Planning and Zoning Board Agenda August 11, 2020

- C. Site Plan – Burger King (16130 NW US Highway 441): A request by Robin Kendall of Quality Dining, Inc., applicant and agent, for T&H Property Group, LLC, property owner, for consideration of a Site Plan to construct a ±3,349 square foot quick service restaurant with associated parking, stormwater, landscaping, and site improvements on a ±1.19 acre subject property. Tax Parcel Number 03061-004-001 (Quasi-Judicial Hearing).

PREPARED BY: Justin Tabor, AICP, Principal Planner

CROSS SECTIONS
BURGER KING
16130 NW U.S. HIGHWAY 441
CITY OF ALACHUA, FLORIDA
SCALE: 1"=20' DATE: 1.15.20
CAD FILE: C05B-SECTIONS
JOB NUMBER: ALACHUA COUNTY
SHEET C05B

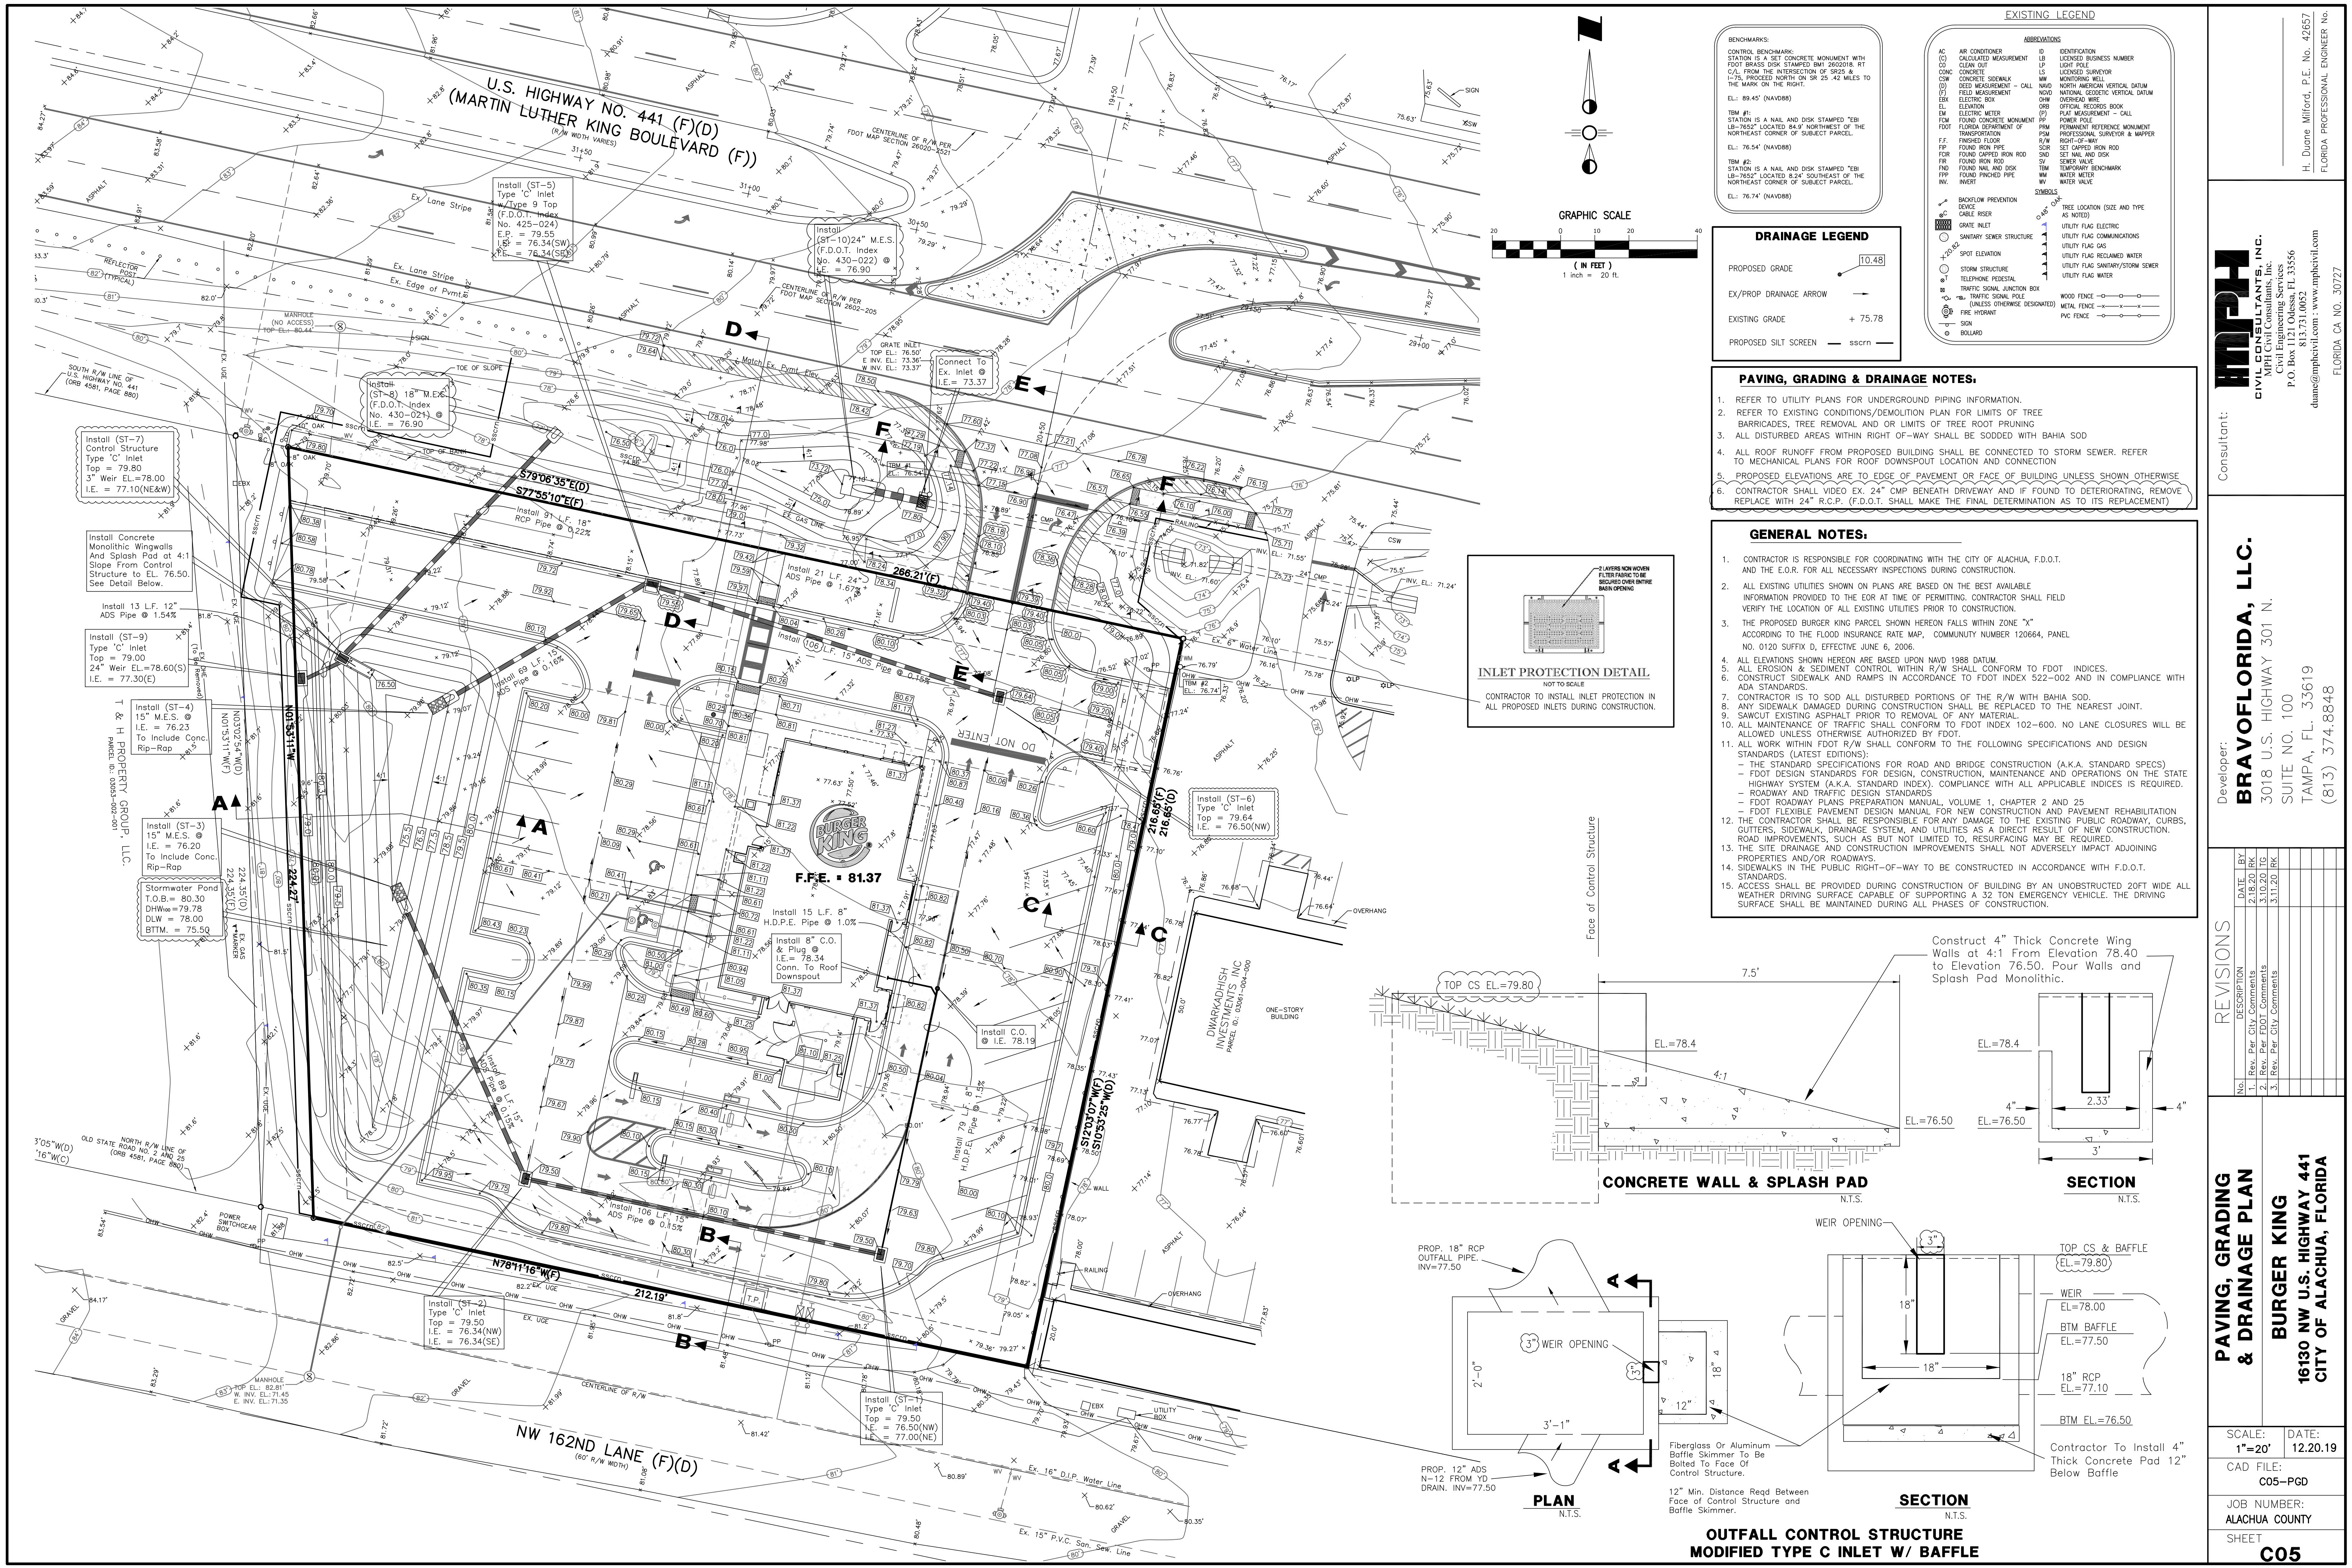
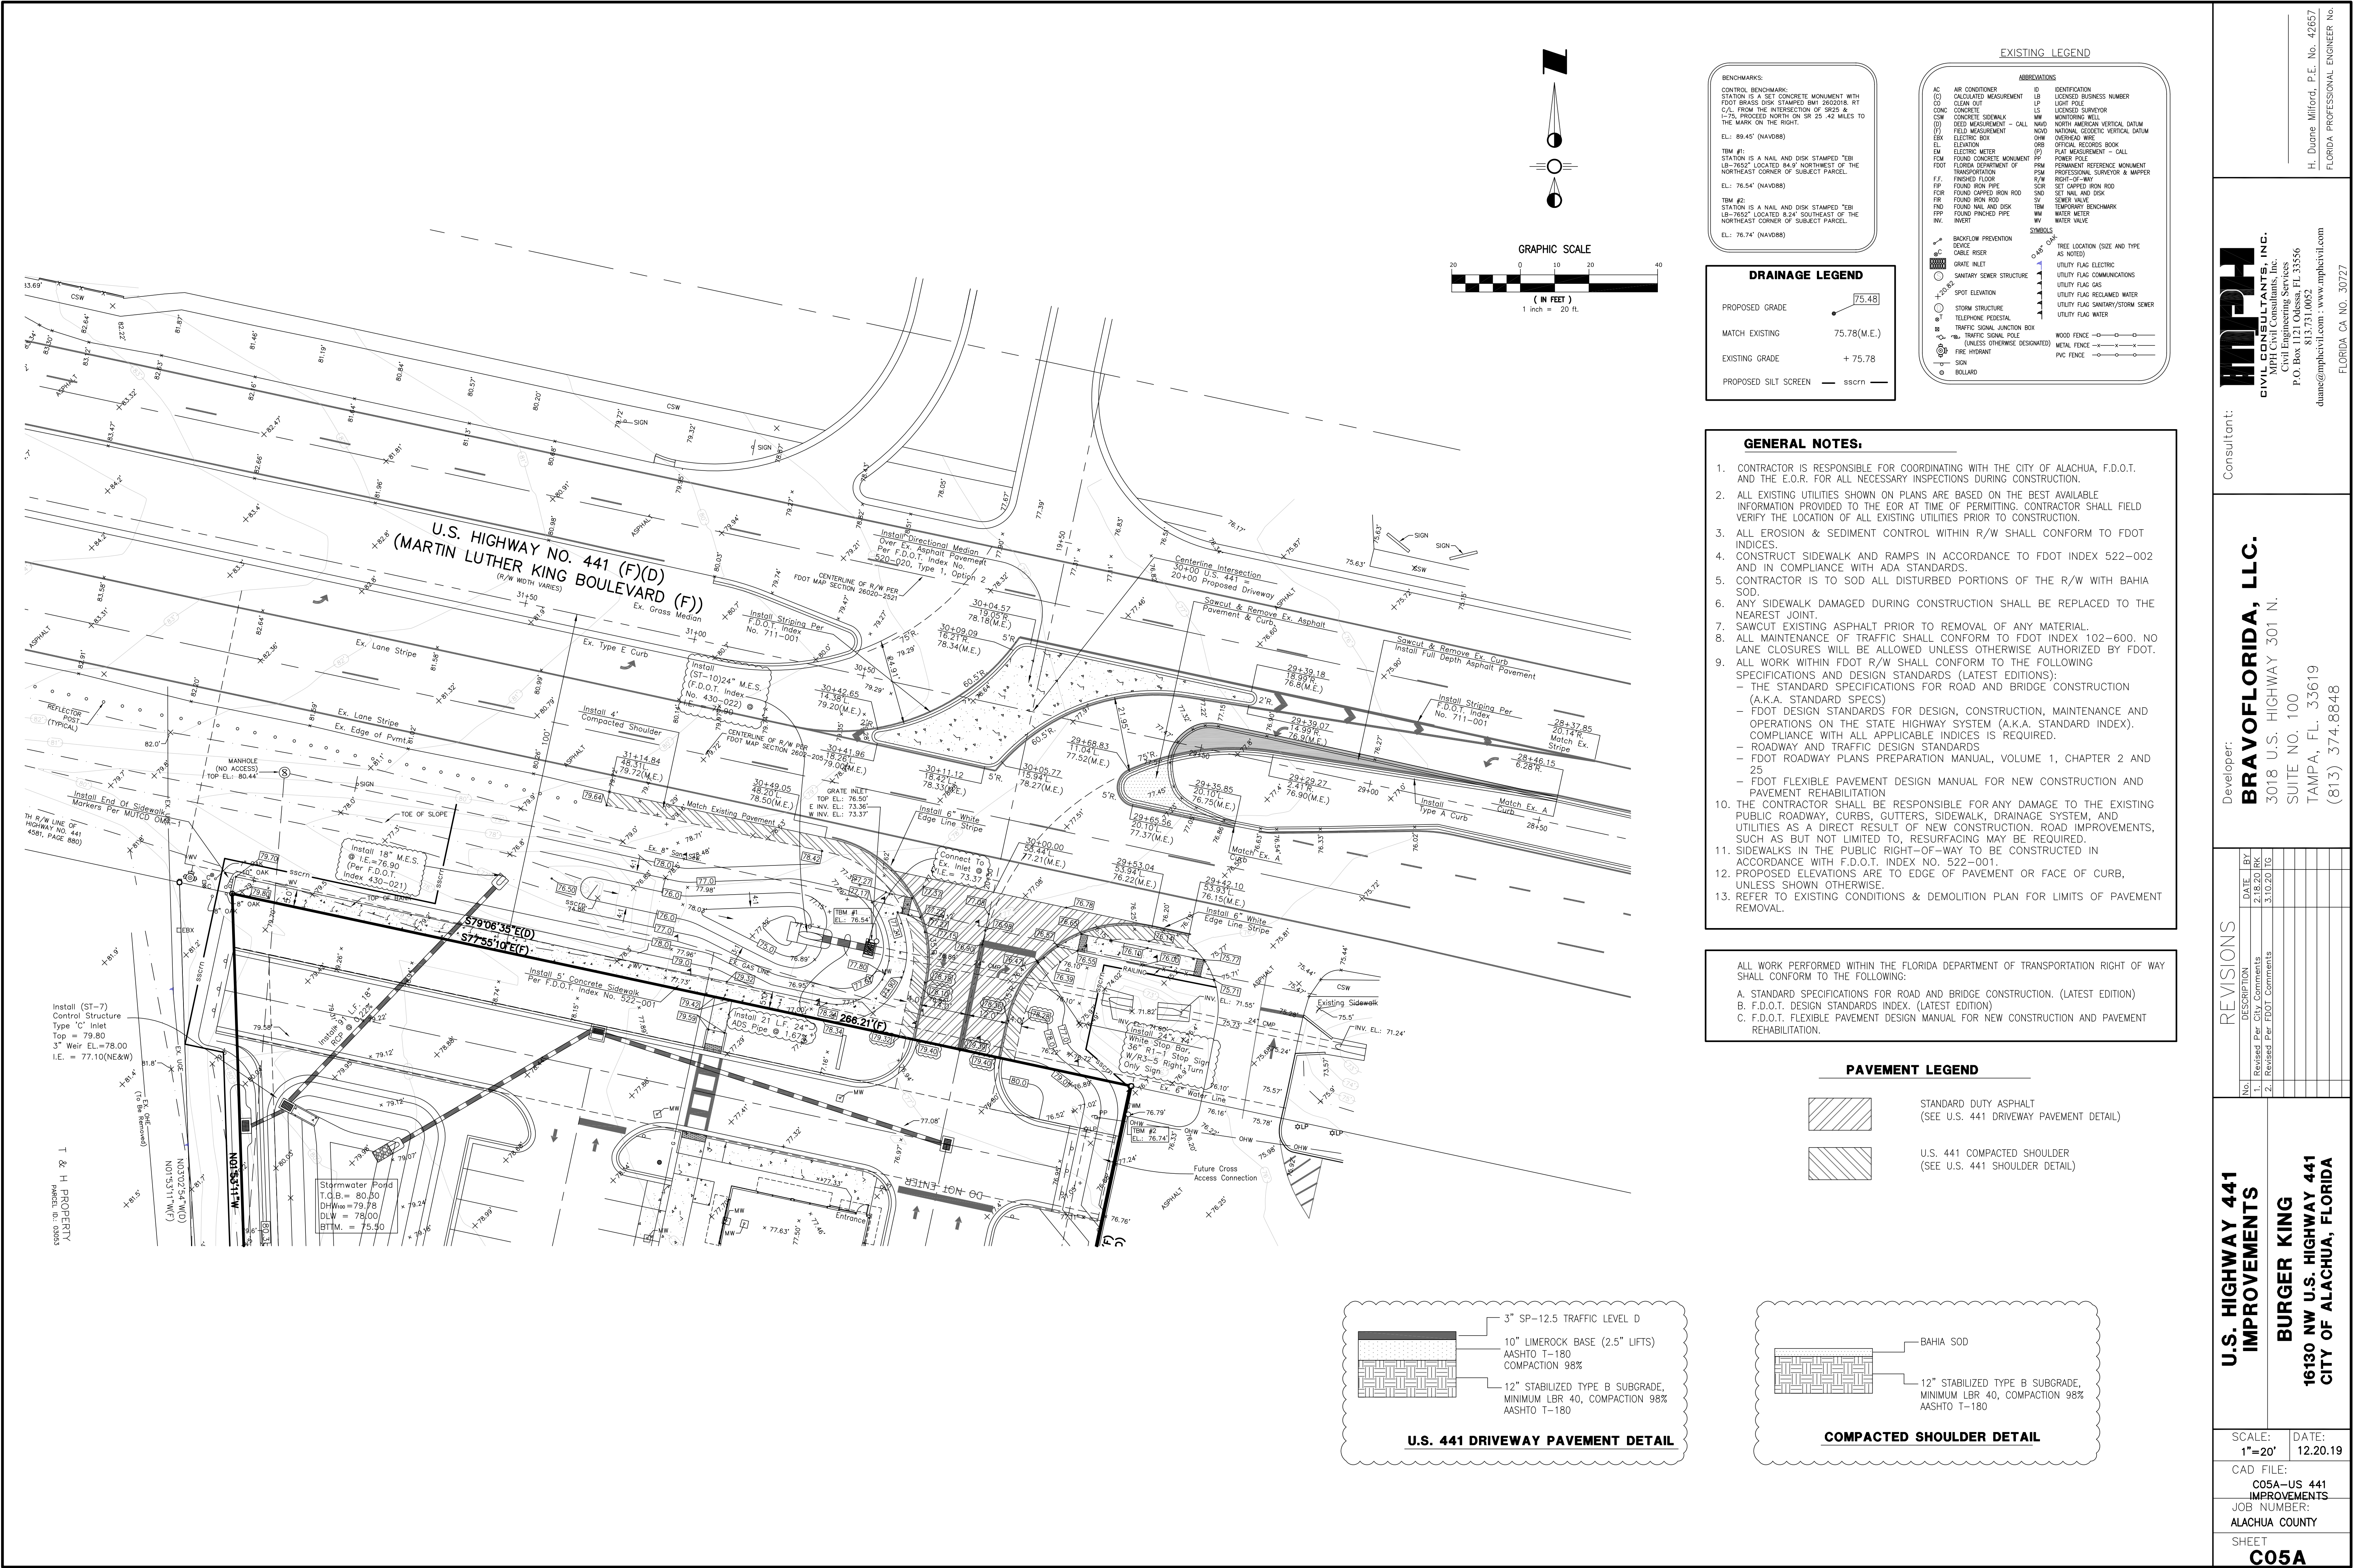
NO.	COMMENTS
	reduces staff-traffic interface.
3.	Comment on Jan 12th Submittal Sheet C05A: To enhance clarity, suggest changing the pavement legend text to: • “Standard Duty Asphalt (See U.S. 441 Driveway Pavement Detail)” • “U.S. 441 Shoulder Asphalt (See Shoulder Pavement Detail)”

Response: Sheet C03 specifies the existing pavement onsite and within U.S. 441. To be removed and sheet C04 and sheet C05A shows the proposed pavement both onsite and within U.S. 441.
